SUBJECT: PLANS AND PROPOSAL ADDENDUMS
PROJECT: STP 2023 (675)MM CONTROL: 1433-02-044
COUNTY: COMAL
LETTING: 05/04/2023
REFERENCE NO: 0419

PROPOSAL ADDENDUMS

DESCRIPTION OF ABOVE CHANGES
(INCLUDING PLANS SHEET CHANGES)

LEGEND

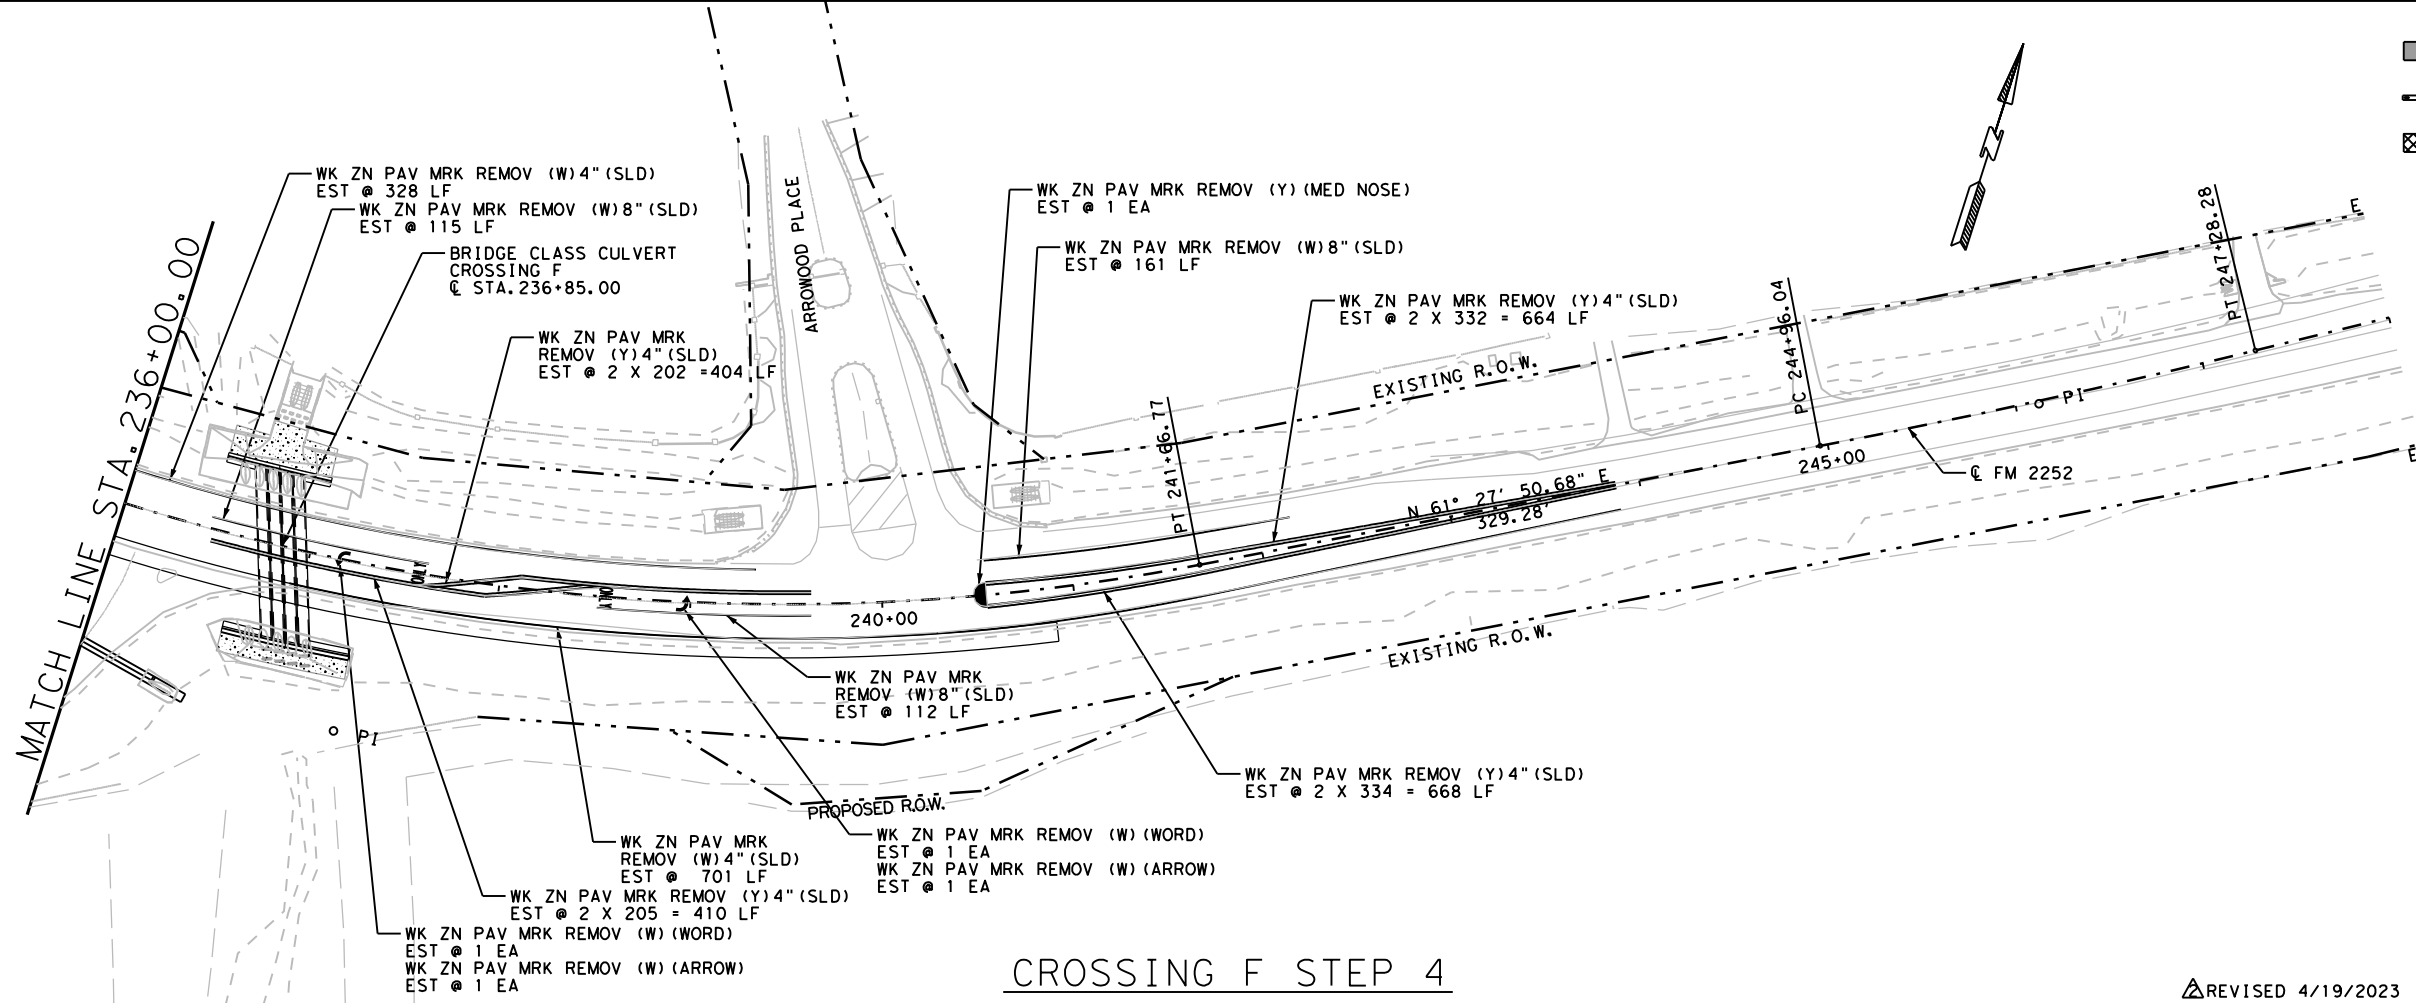
SHEETS 275-278, 280-283, 285-288 AND 290-293: ADDED ITEM NO. 403-6001

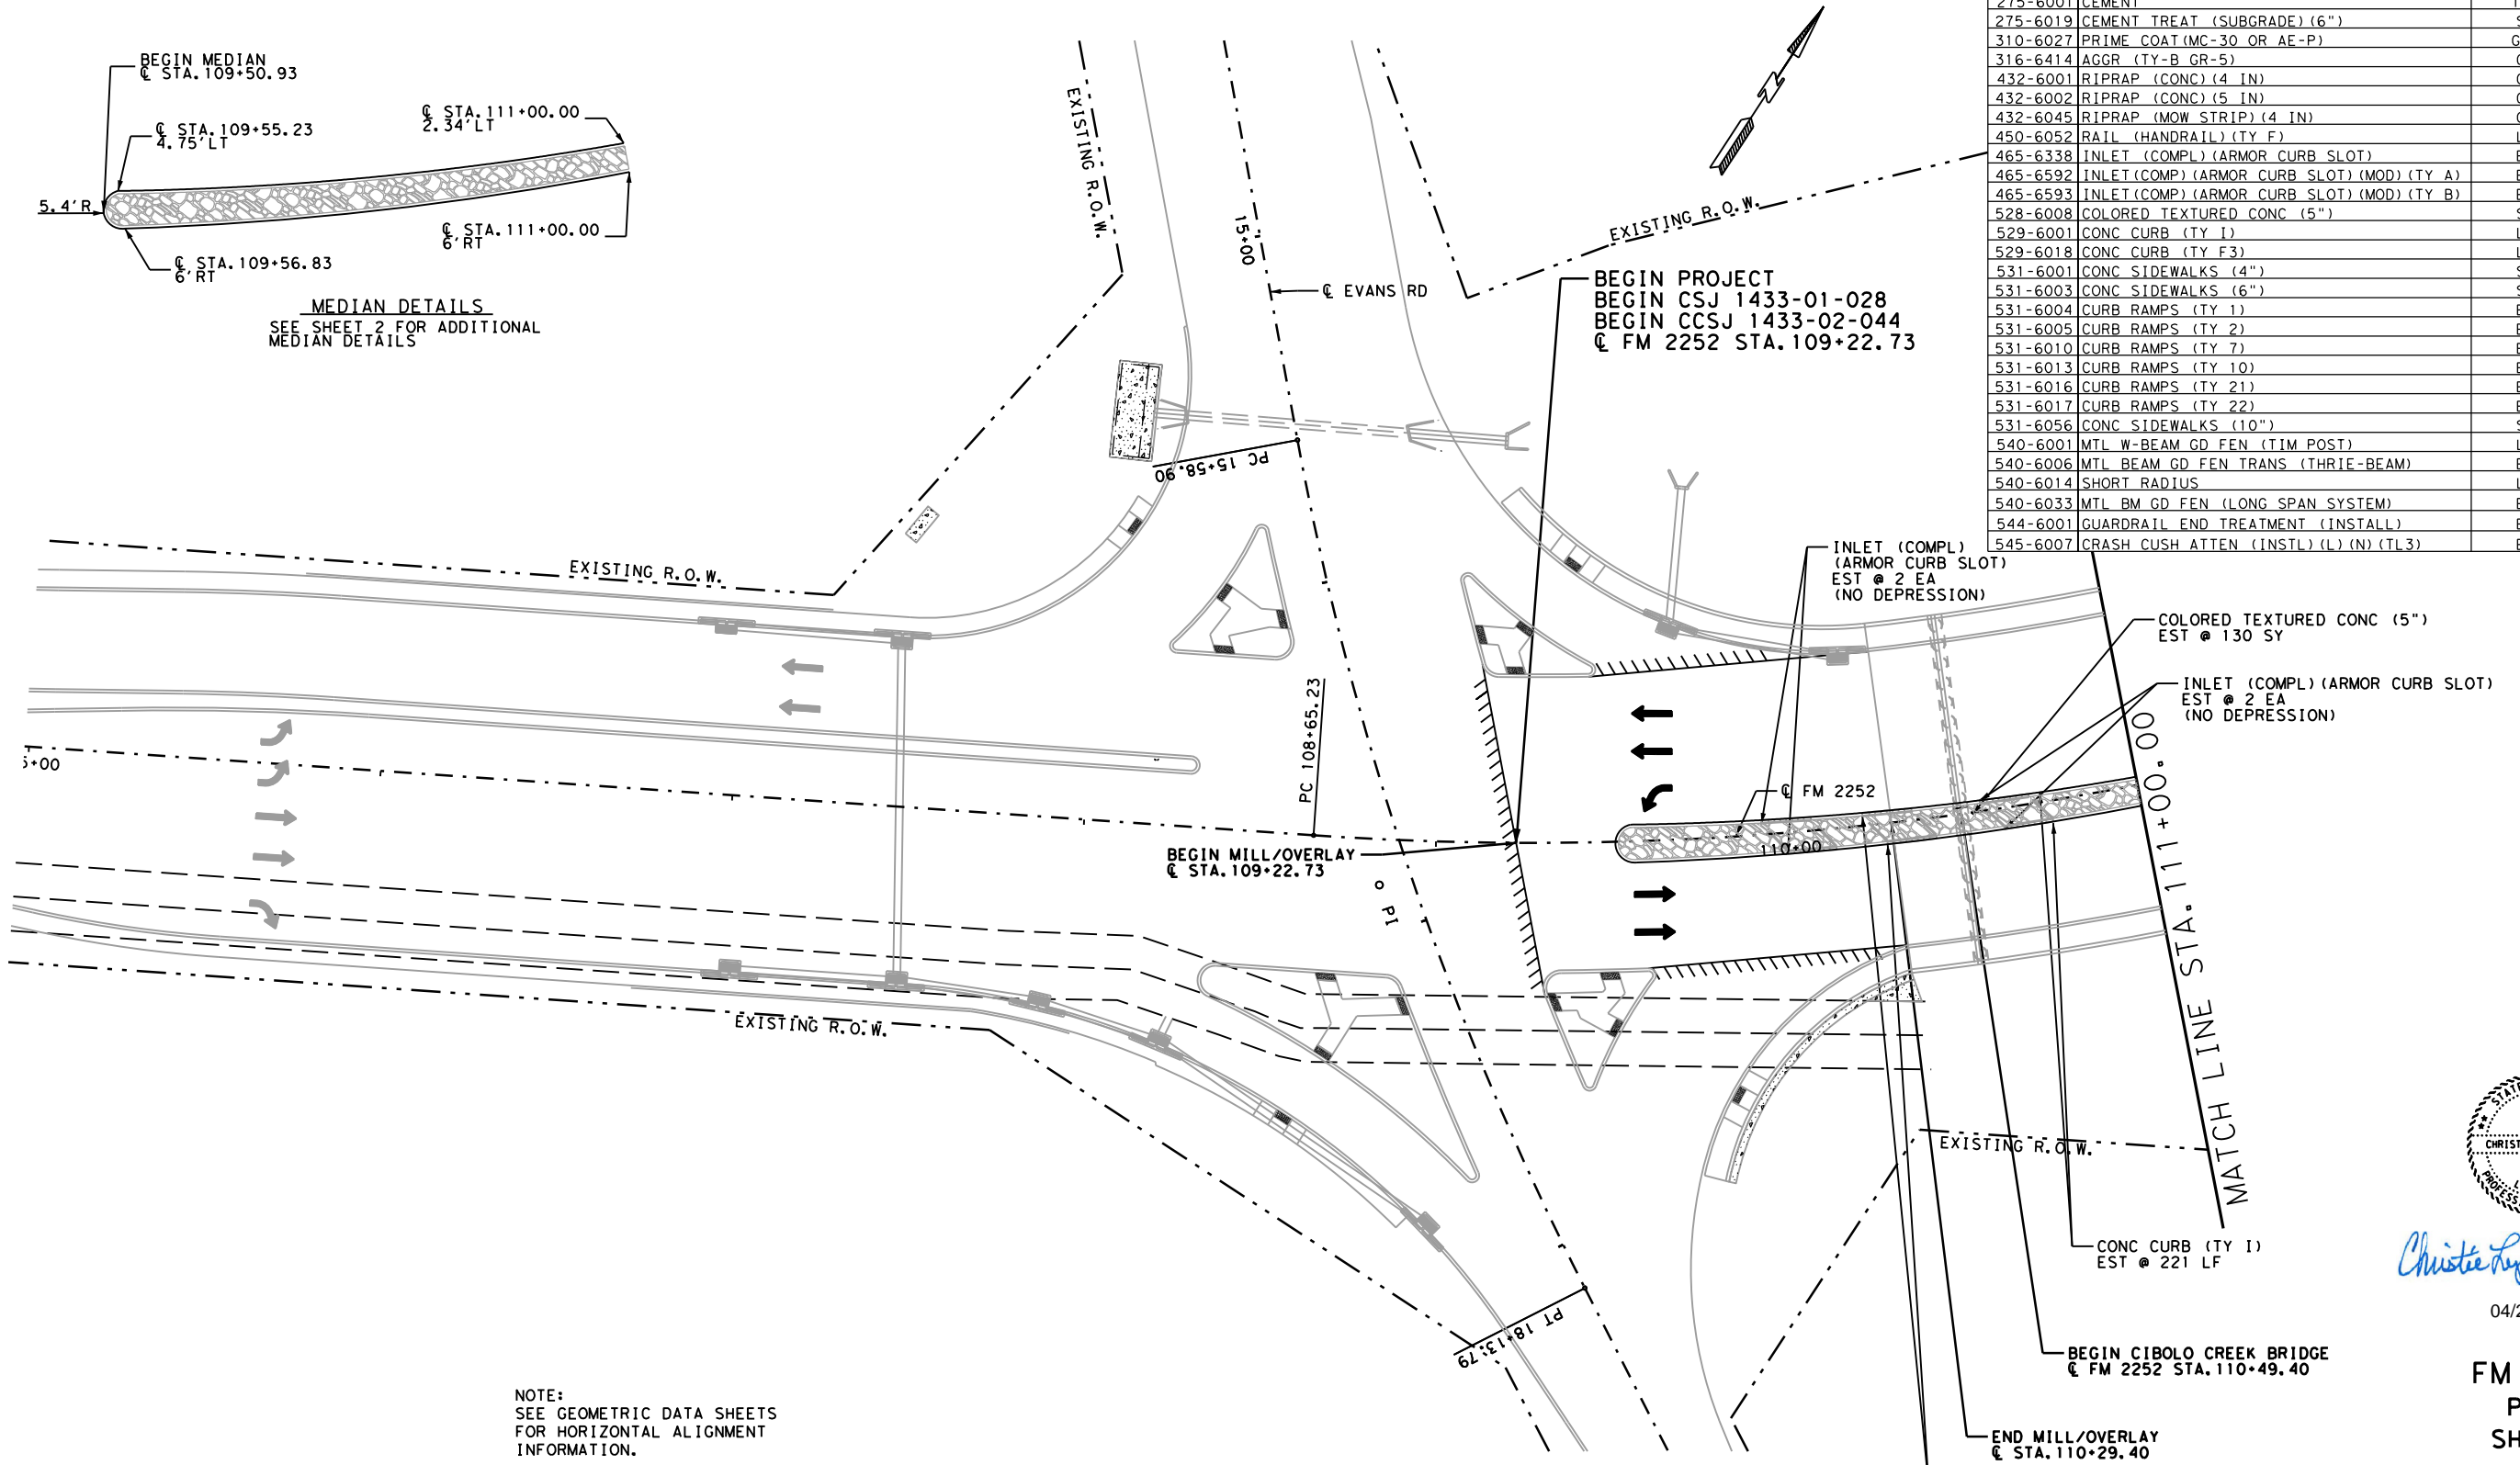
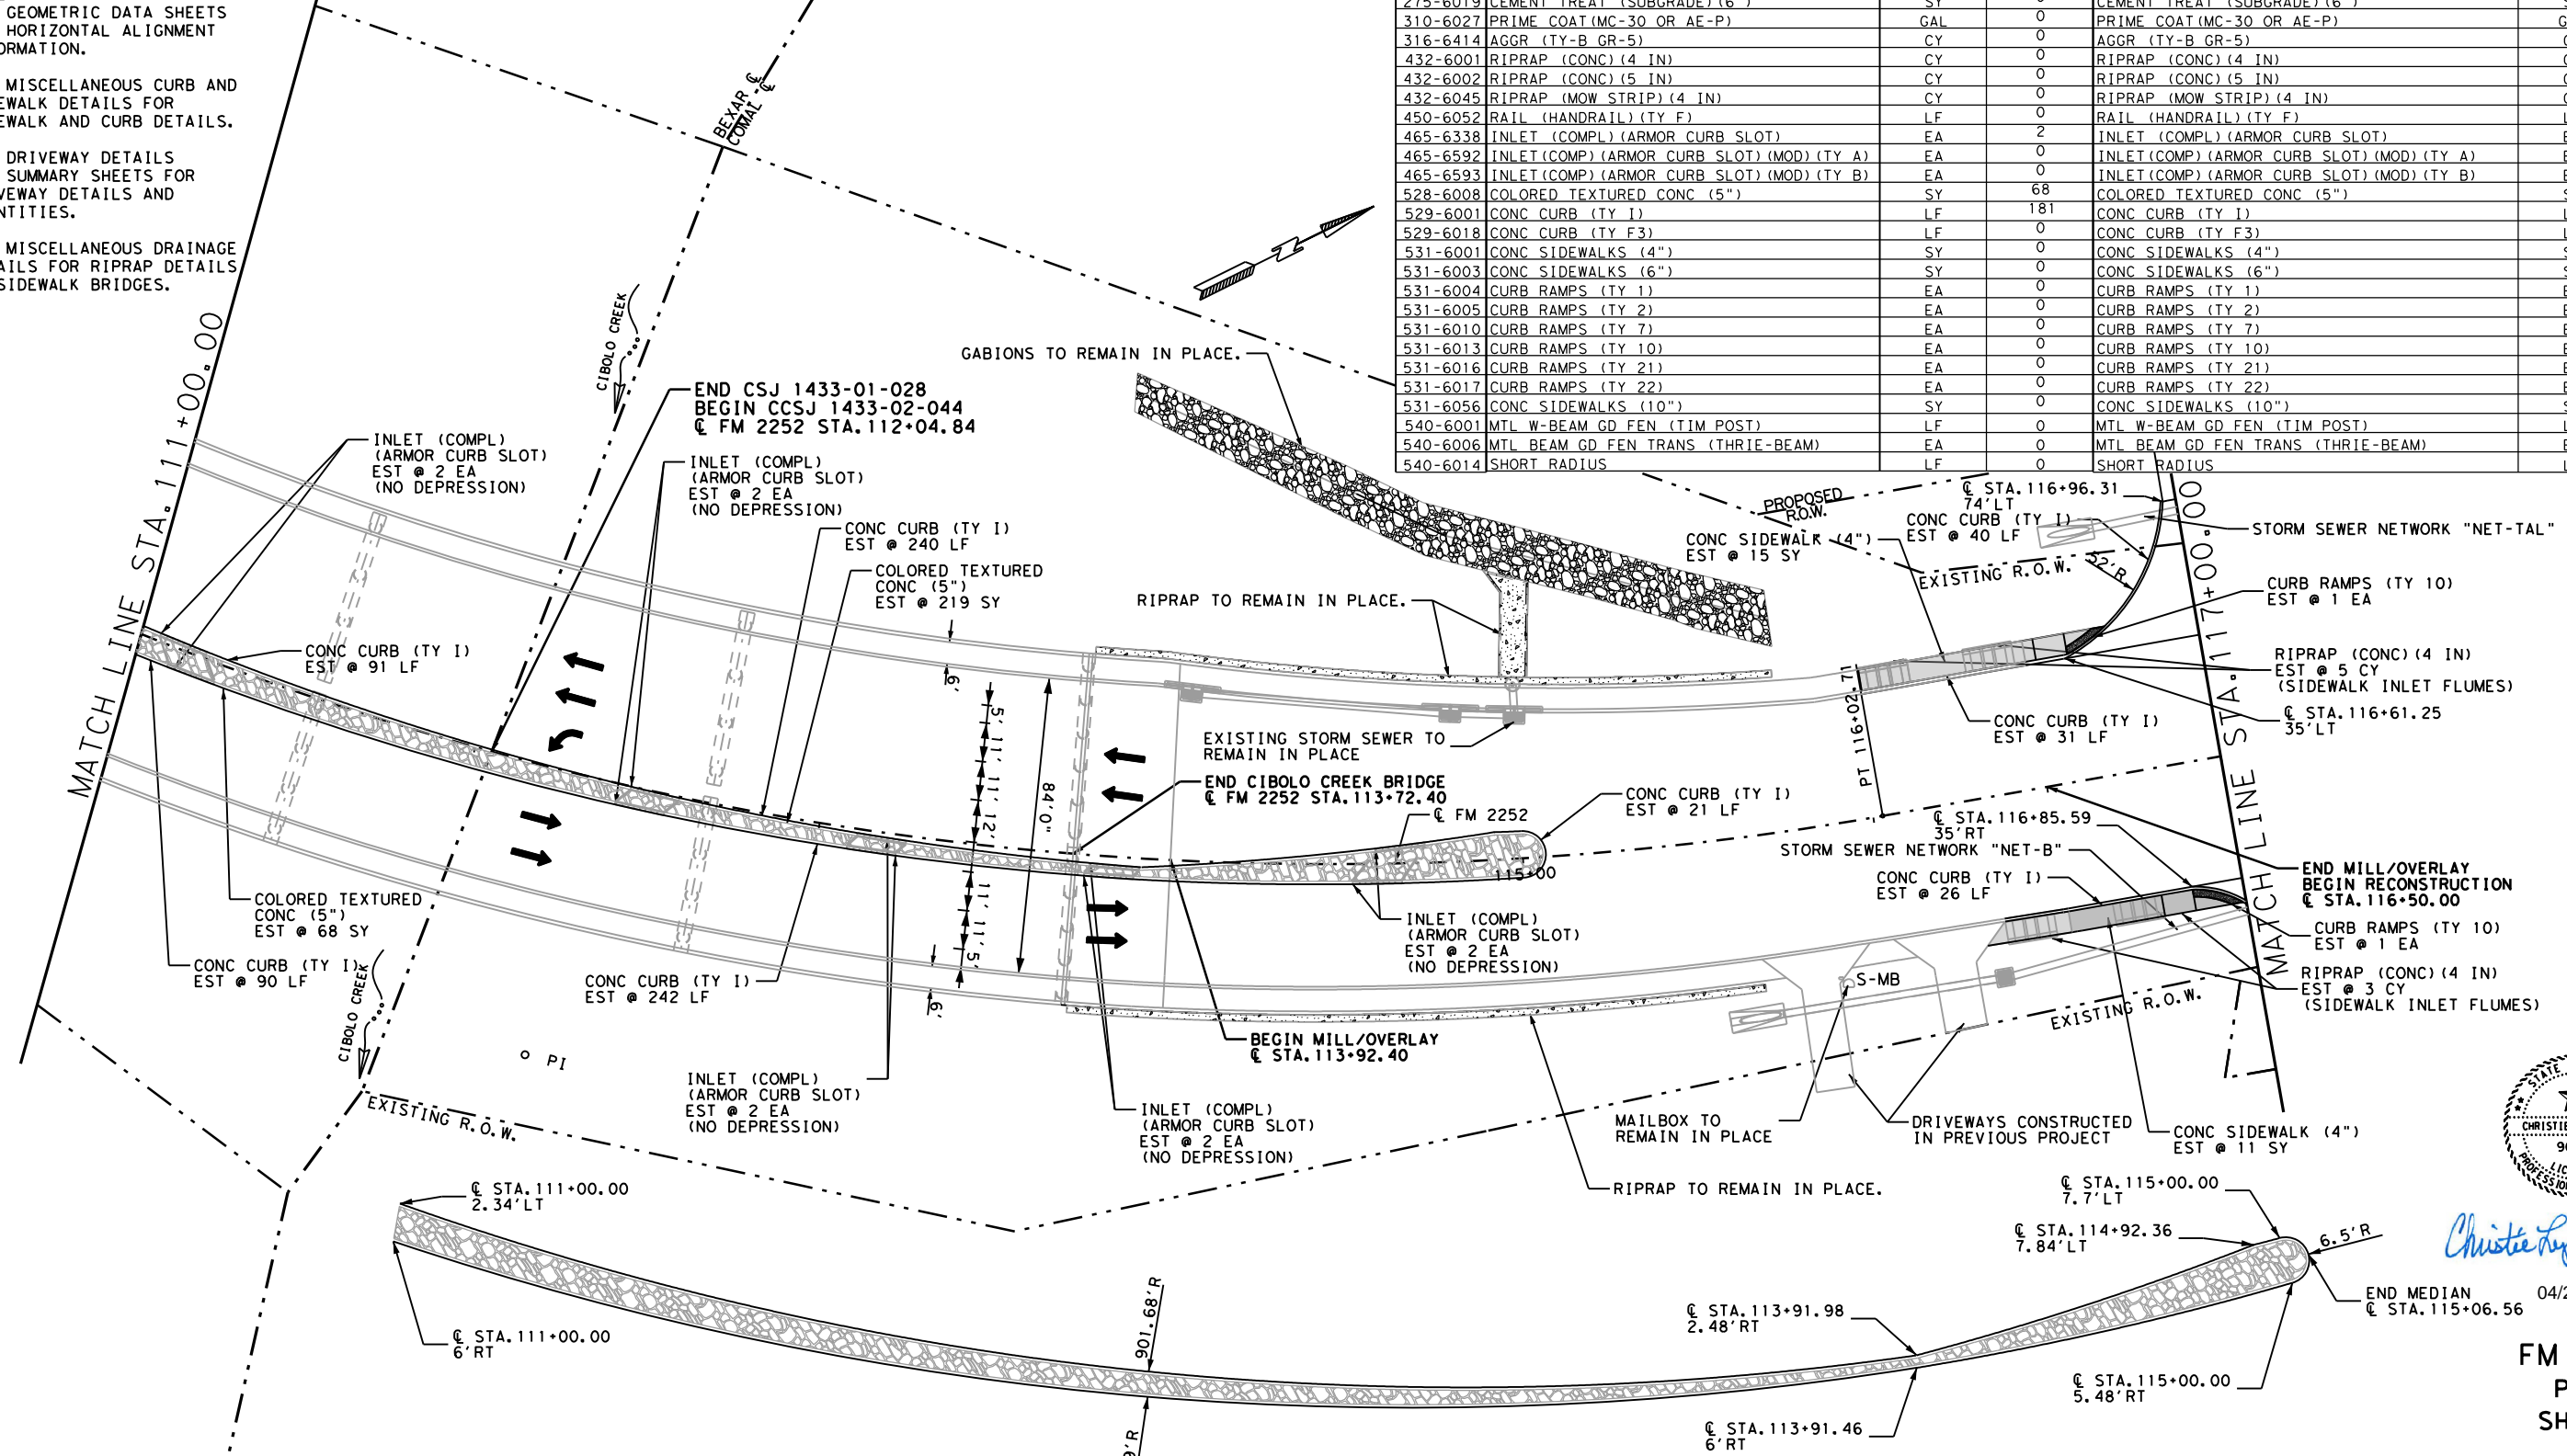
SHEETS 413-449: REPLACED ITEM NO. 545-6017 WITH ITEM NO. 545-6007
